Purpose: To install an Eco-Cool Soft Start onto a Gree Air Conditioner.

Models Involved: 2025 & 2026 Tiffin GH1 and GT1 Motorhomes

Installing Eco-Cool Soft Start

PPI-SG-GREE-006

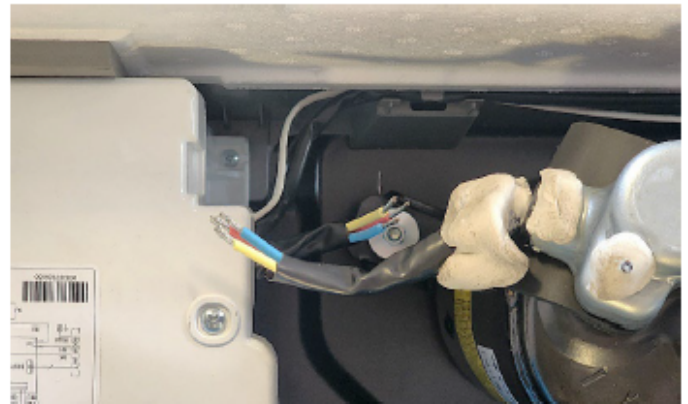
1. Remove the exterior cover & locate the compressor harness running between compressor and electrical box. Remove 2"-3" of the protective sheath, roughly centered between electrical box and compressor. Cut each wire, then use wire strippers to prepare each for reconnection.

2. Connect the "COMPRESSOR" side to the prepared wires from compressor, then secure with wire tie as shown above. Connect the "SUPPLY" side to the prepared wires from electrical box using same processing.

3. Use remaining wire ties to secure access wiring. Clean surface of electrical box, then mount soft start using supplied double side tape. Use the in-board mounting screw of the electrical box cover (blue) as a point of reference when mounting and align with soft start as shown above. Reinstall the exterior cover and test.
